ATTACHMENT ONE
ENCLOSED AS PART OF SIERRA CLUB CALIFORNIA
COMMENTS ON THE CAHSR DRAFT EIR/EIS

Sierra Club/Loma Prieta Chapter 8/28/2004 Response Letter: CAHSR- DRAFT EIR/EIS

Thalys HST at Paris-Nord Station

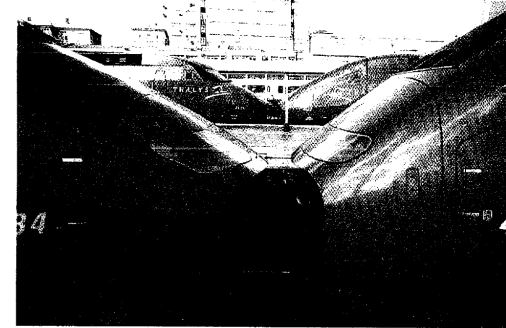
While factually correct, the length of this footnote is misleading as this implies that High Speed Train (HST) splitting is a difficult task. HST splitting is not difficult as demonstrated by the above image, which shows two joined Thalys train sets⁵. As can be seen from the map below, the operators of the Thalys-HST route need to service two scattered final destination cities, Amsterdam and Cologne. The operators of the California system will face the same situation of servicing Sacramento and San Francisco from Los Angeles. Twenty-two times every day, the Thalys operators join and separate two train sets. As can be seen from the Thalys schedule (refer to *Appendix 12*), it takes less than 5 minutes to perform this task.
